S E R V I C E N O T E

E4401B, E4402B, E4403B, E4404B, E4405B, E4407B, E4408B, and E4411B ESA Spectrum Analyzer family. Also E7401A, E7402A, E7403A, E7404A, and E7405A EMC Pre-Compliance Analyzers.

Intermittent screen "flicker" due to a cold solder joint

DATE: January 2001

Figure 1

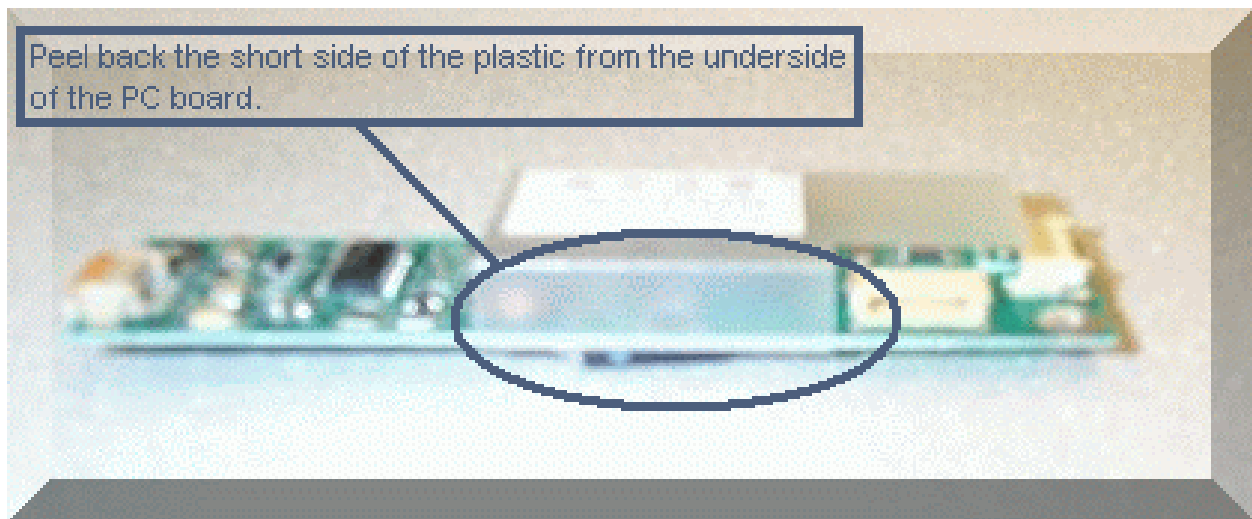
Instruments within the above serial range can experience an intermittent screen "flicker" due to a cold solder joint on pin 7 of the transformer on the backlight inverter board. The backlight inverter board attaches to the front panel interface board (A1A1) on the analyzer. The attached figures below in the Solution/Action section can be referenced on the procedure to use to correct for this problem.

- 1) Peel back the plastic shield on the backlight inverter board. See Figure 1.

Figure 3

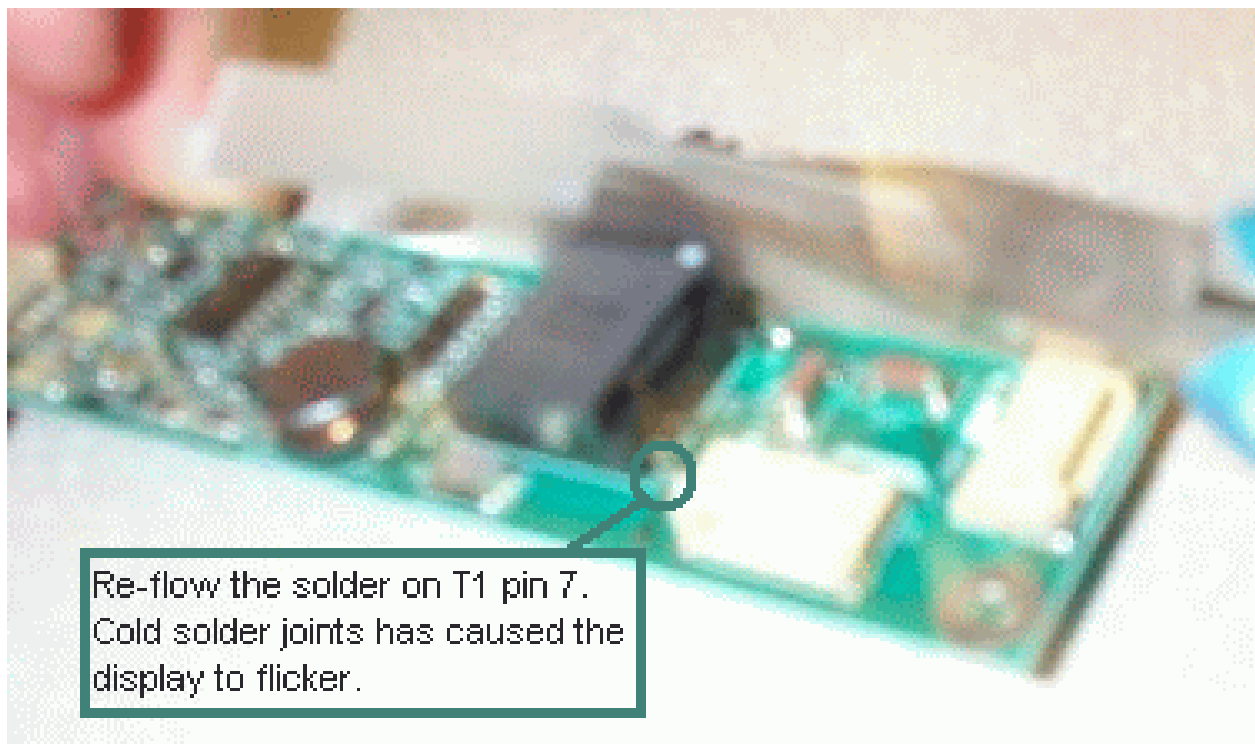
The backlight inverter board and LCD display are procured together as an assembly from NEC. Manufacturing has troubleshot screen flicker issues to poor solder quality on pin 7 of the transformer on the backlight inverter board. NEC has been notified and an inspection process implemented in manufacturing to cure this problem.

3) Re-solder pin 7 of the transformer on the backlight inverter board. See Figure 3.
